Minor Changes Key

Project 60 Whitfield Street

Title Proposed Elevation - Howland Mews

Drawing No 60WS-A-SBA-DR-XX-4008-C3

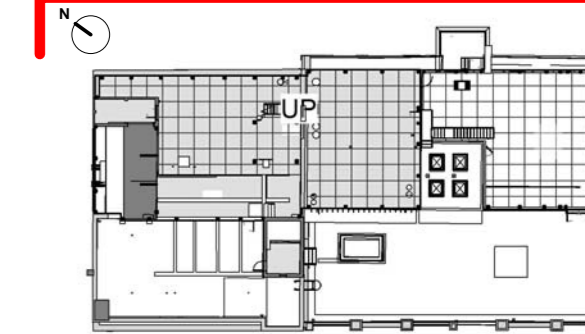
- Planning Approval Building Boundary
- - - Planning Approval Plant Boundary
- ① Louvre added to enclose MEP
- ② Existing enclosure of Goldbeaters atrium is retained except two lateral walls
- ③ Scope of demolition of existing plant room on Walport building increased
- ④ Minor repositioning of approved flues
- ⑤ Maintenance cat ladder added to link Goldbeaters terrace with Walport terrace
- ⑥ Amended stair-landing levels
- ⑦ Parapet of dumbwaiters enclosure raised by 235mm
- ⑧ Reduced louvre height to match Howland Mews elevation
- ⑨ One section of window removed
